ADDENDUM

PROJECT: Eastridge Presbyterian Church
Phase II - Education Wing Renovation
Lincoln, Nebraska

AD-2

DATE ISSUED: Friday, May 4, 2012

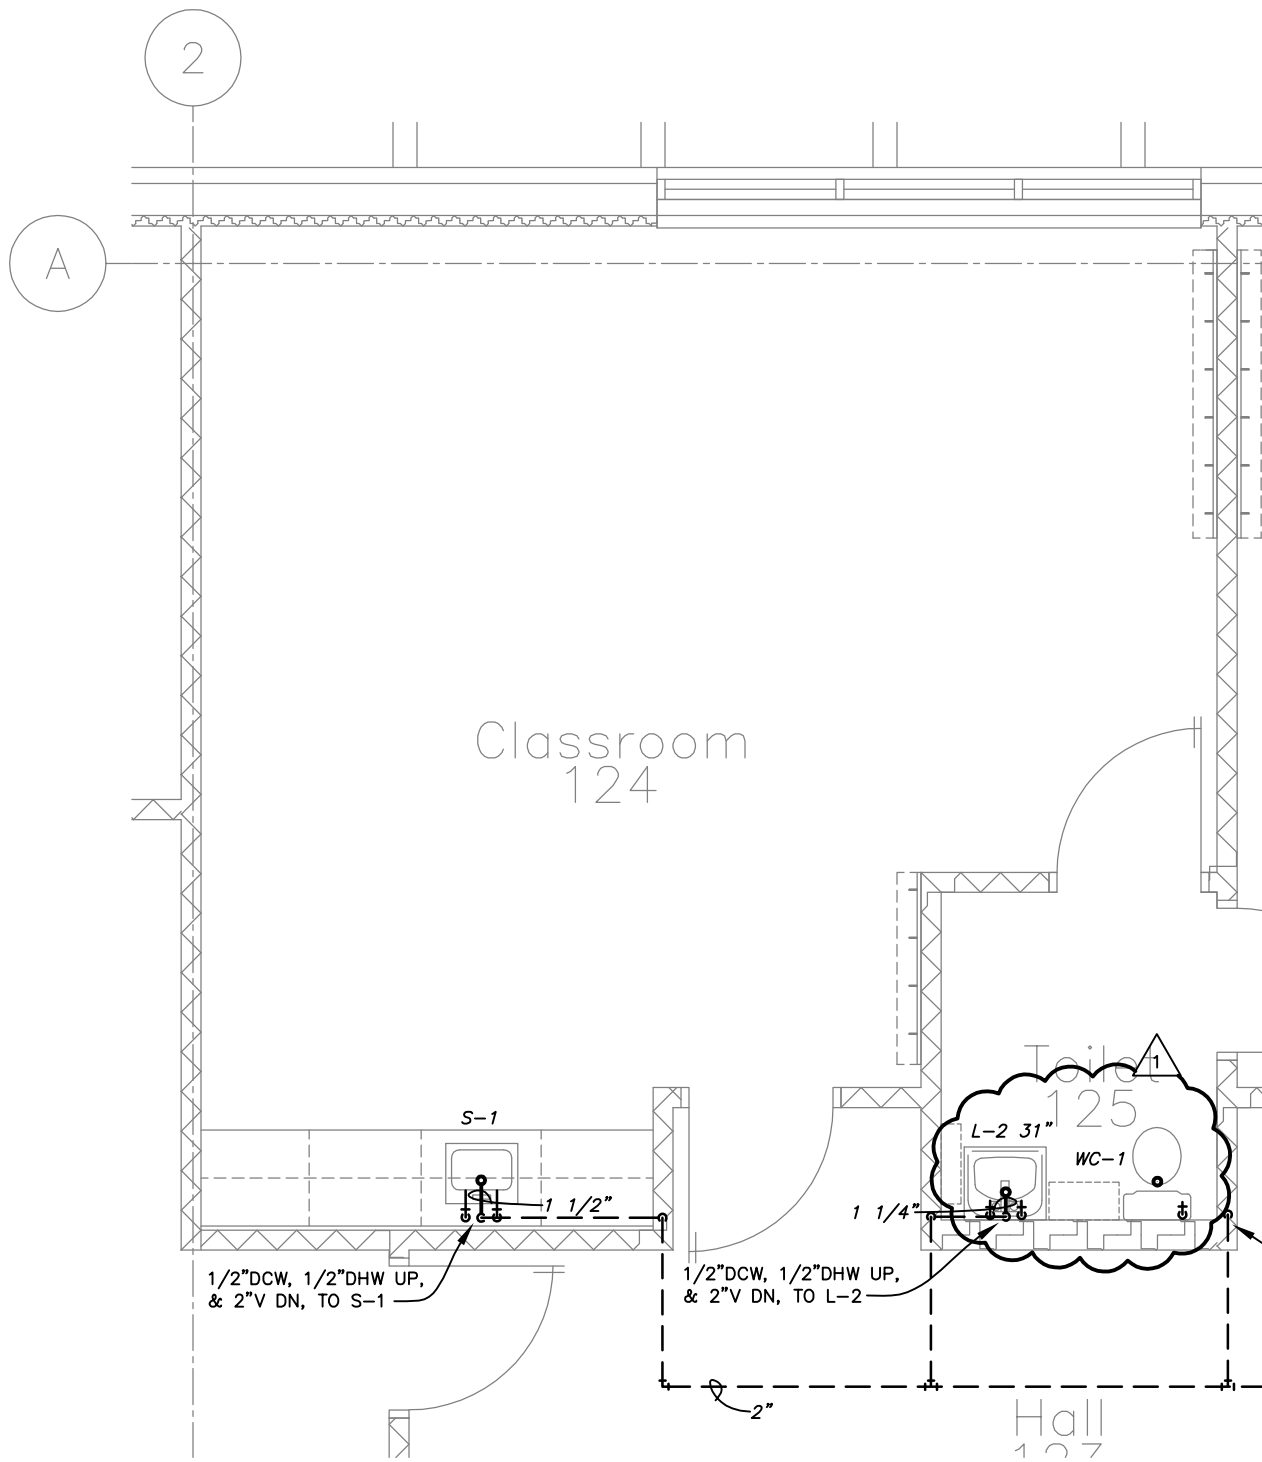
In reference to drawing Sheet P-104, the water closet in Toilet 127A and Toilet 125 shall be labeled as WC-1. Please refer to attached drawing P-104.1 and P-104.2.

Drawing # E-102.1

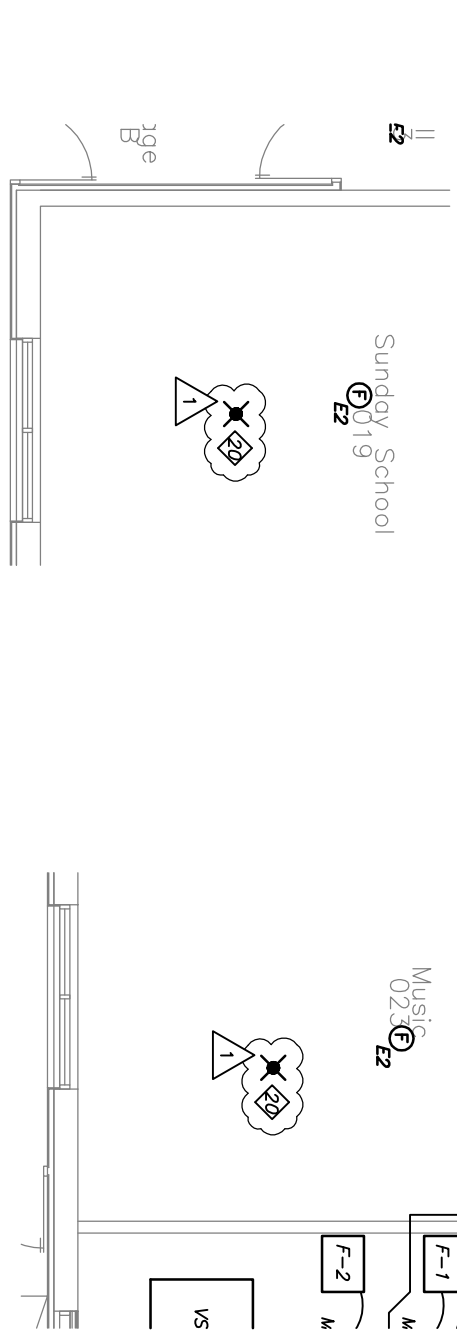
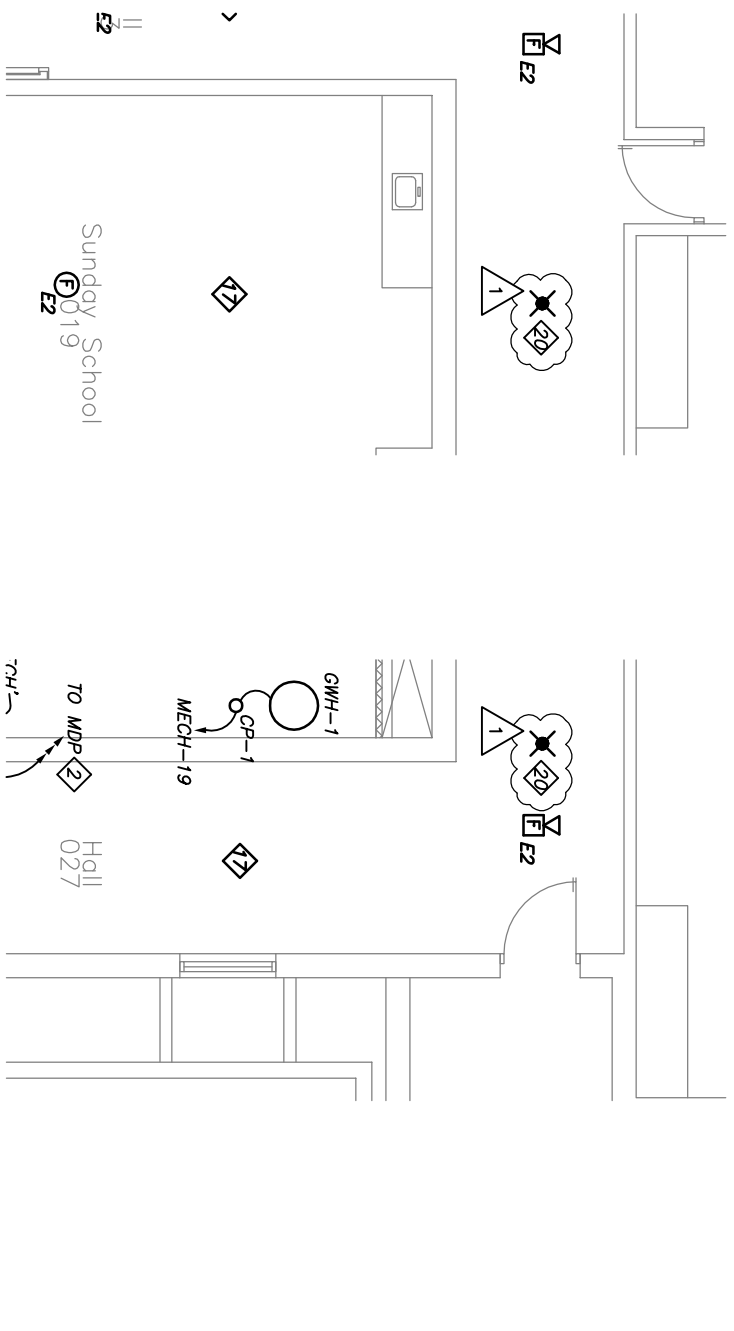
In reference to drawing Sheet E-102, see attached Sheet E-102.1 for additional work.

Drawing # E-102.2

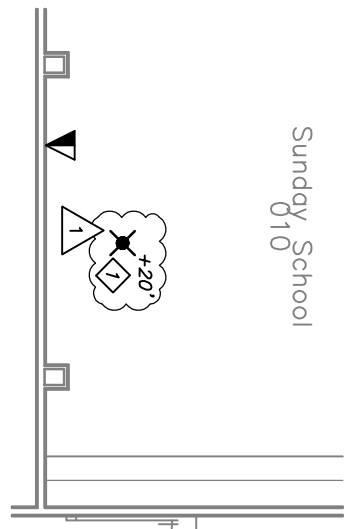
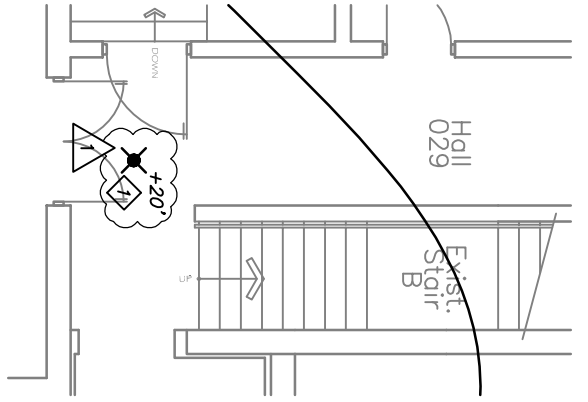
In reference to drawing Sheet E-102, see attached Sheet E-102.2 for additional work.

1
 20 PROVIDE ONE DATA DROP ABOVE THE CEILING IN APPROXIMATELY THIS LOCATION FOR A WIRELESS ROUTER TO BE PROVIDED BY OTHERS. COORDINATE FINAL LOCATION OF DROP WITH OWNER'S IT CONSULTANT. WHERE NOTED WITH "+20" PROVIDE 20' OF COILED CABLE FOR LOCATION ADJUSTMENT, OTHERWISE PROVIDE 6' OF COILED CABLE.

From Sheet:
E-601
for CA use:
Drawing #
E-601.1

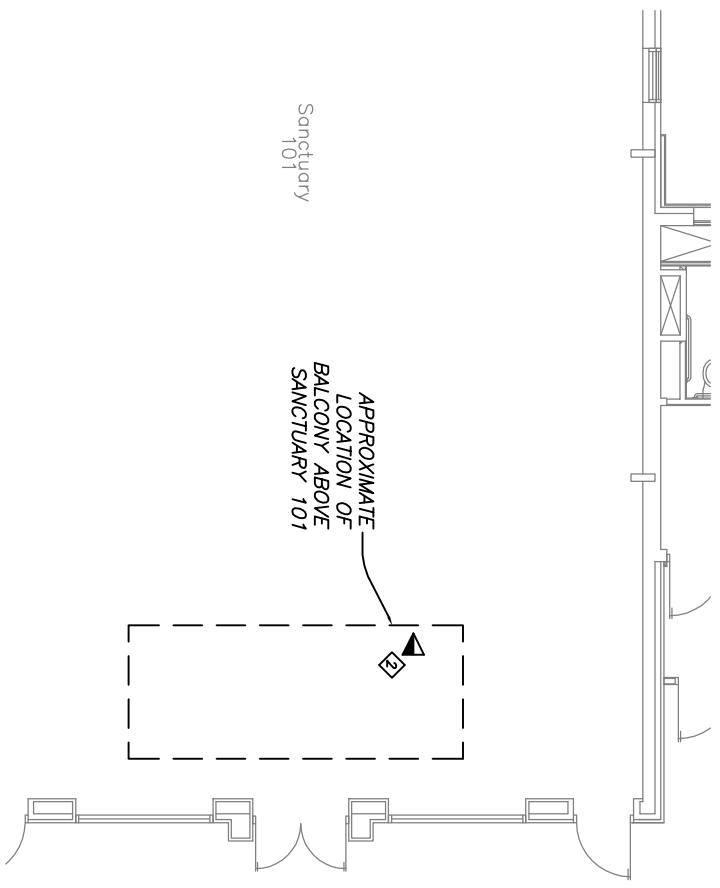
In reference to drawing Sheet E-601, see attached Sheet E-601.1 for additional work.

1 PROVIDE ONE DATA DROP ABOVE THE GELING IN APPROXIMATELY THIS LOCATION FOR A WIRELESS ROUTER TO BE PROVIDED BY OTHERS. COORDINATE FINAL LOCATION OF DROP WITH OWNER'S IT CONSULTANT. WHERE NOTED WITH "+20'" PROVIDE 20' OF COILED CABLE FOR LOCATION ADJUSTMENT, OTHERWISE PROVIDE 6' OF COILED CABLE.

2 PROVIDE A NEW COMBINATION TELEPHONE & DATA RECEPTACLE WITH ONE DATA AND ONE TELEPHONE CABLE AT THE BALCONY ABOVE THE SANCTUARY. COORDINATE FINAL RECEPTACLE LOCATION WITH OWNER'S IT CONSULTANT PRIOR TO ROUGH IN.
